# **RENNIA ENGINEERING DESIGN, PLLC**

May 15, 2018

**Re: R & R Concrete  
Town of Amenia  
Parcel ID: 132000-7165-00-001698**

This letter is written in response to comments received from the Planning Board Attorney, David R. Everett, Esq., and Planning Board Engineer, John V. Andrews, Jr., P.E., regarding material for the R & R Concrete project, submitted to the Planning Board on April 5<sup>th</sup>, 2018.

**R & R CONCRETE**  
 TOWN OF ANDOVER  
 SCALE: 1" = 20'  
 SHEET NO. 2 OF 5

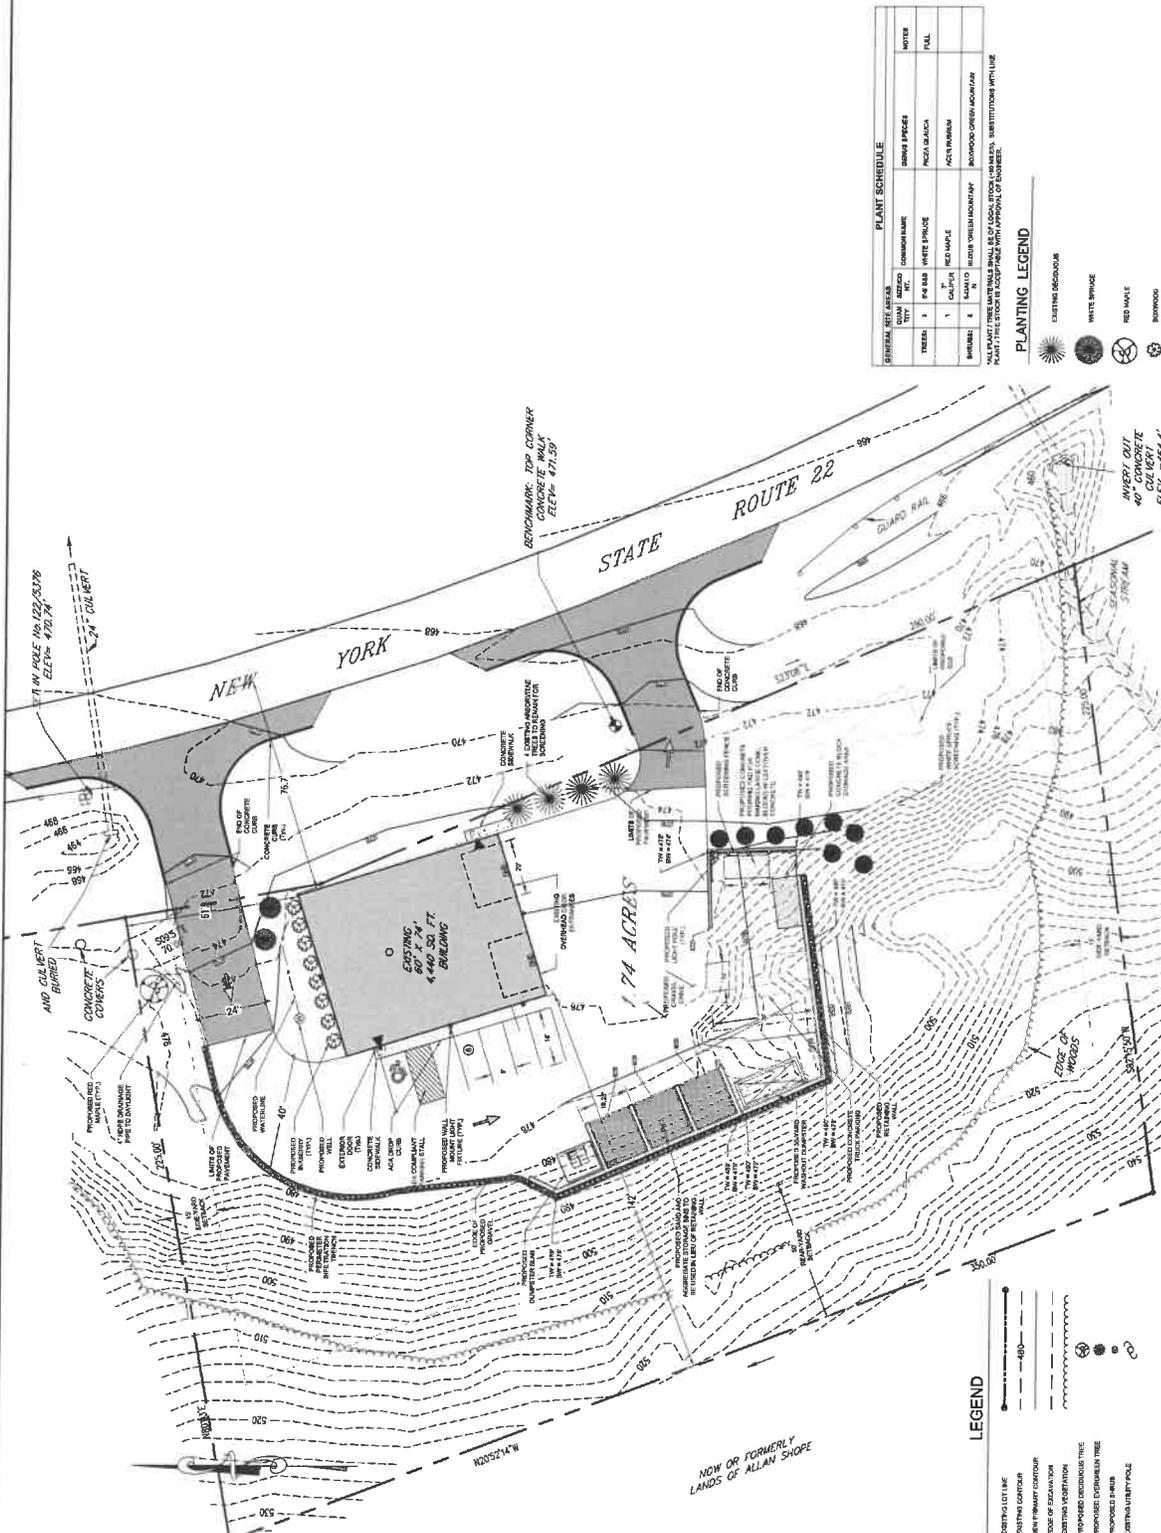
7. The Site Plan has been updated to include a note under the Bulk Regulations table stating "Front setbacks are measured from centerline of road. "The side yard setbacks actually appear to be 15', as the parcel abuts an Agricultural District rather than a Residential District.
